STAFF REPORT
E & M REMODELING & CONCRETE
SIX-PUMP GAS STATION
SITE DESIGN REVIEW SDR 1-23
APRIL 19, 2023

Proposed Condition: Six-pump gas station with 2,940 sf convenience store

City of Cottage Grove File(s): CUP 1-23 and SDR 1-23

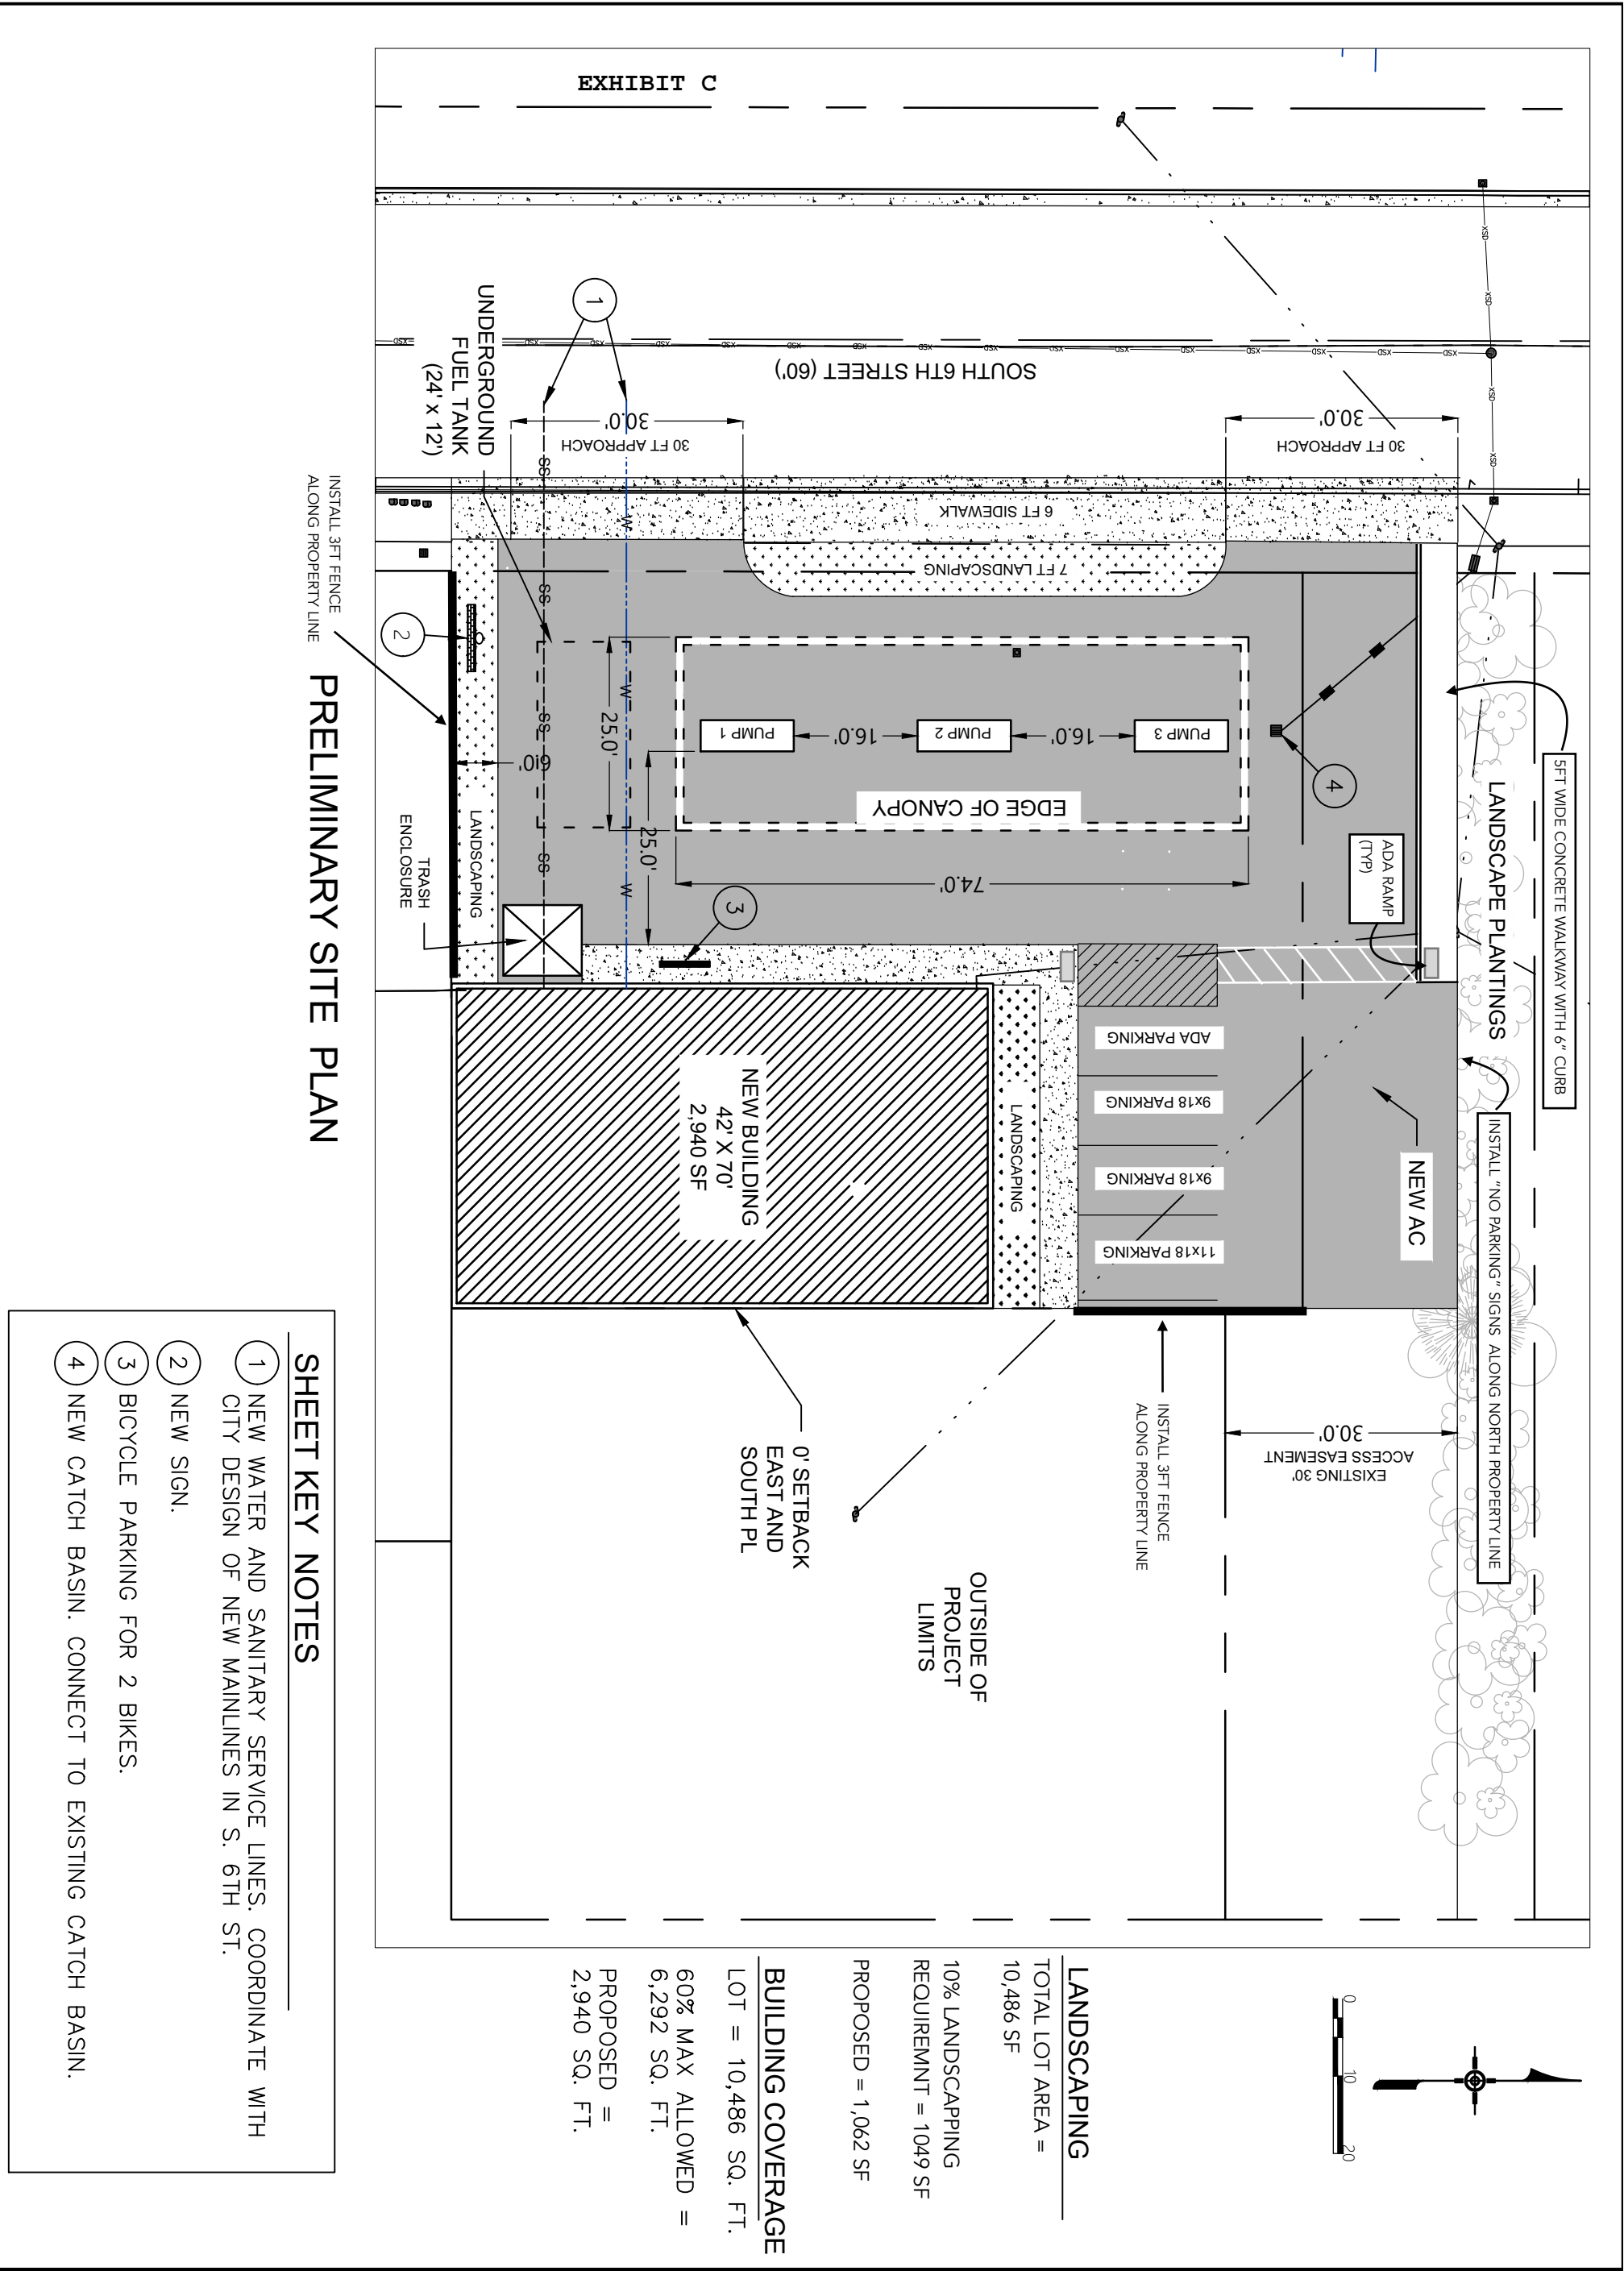
Receiving the proposed site plan has created some concerns and suggestions:

- ~ The setback means the building roof and /gutter should not cross the property line.
- ~ What will the outside walls be constructed of, since future access could be denied?

- ~ What is the height of the back and side walls? At this point there does not seem to be enough space for customers to park, since many times there can be as many as six cars at the store. We don't see any additional parking shown in front.
